RESOLUTION NO. 892

A RESOLUTION OF THE CITY COUNCIL OF THE CITY OF GIG HARBOR, WASHINGTON, AMENDING THE WASTEWATER COMPREHENSIVE PLAN BY REVISING THE SEWER COLLECTION BASIN BOUNDARY BETWEEN SEWER COLLECTION BASINS #3 AND #17.

**WASTEWATER
COMPREHENSIVE PLAN
AMENDMENT
FOR
EVERGREEN
BUSINESS CENTER**

NOVEMBER 23, 2011

BASIN MAP

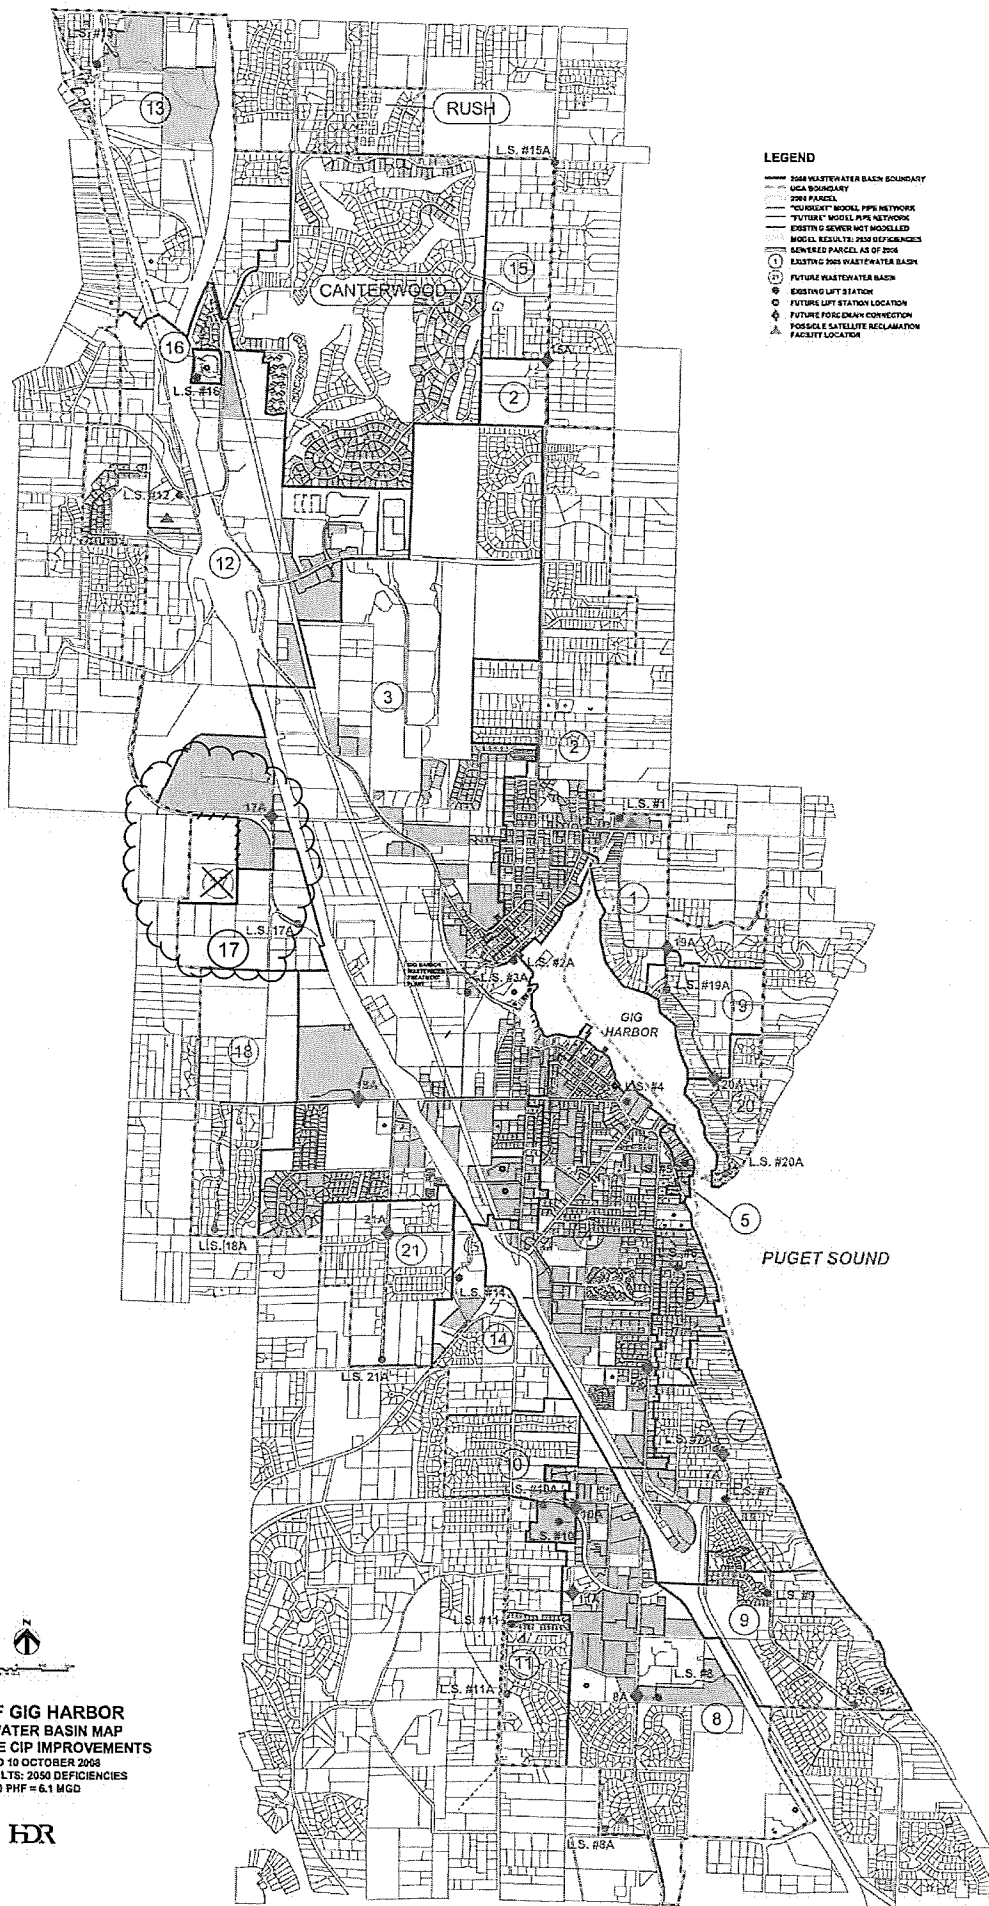
Due to timing, costs, and the fact there is another viable option via gravity flow, it is our proposal to modify the boundary line between Basin 3 and Basin 17 to now include the above mentioned parcels in Basin 3; refer to the revised Wastewater Basin Map attached. With all discharge being conveyed through Lift Station 3A, the reconfiguration of the demand from Basin 17 directly to Basin 3 should not adversely affect this lift station or the wastewater treatment plant. Since Lift Station 17A is still a future lift station, and according to the current Comprehensive Plan does not have a scheduled

date, the design can reflect this change in the future and a cost savings will also be incurred for the City by the need for a smaller lift station.

Section 2. Appendix B of the WWCP shall be amended to reflect the revisions to the Wastewater Basin Map as provided in the November 23, 2011 EBC Project sewer hydraulic report; and
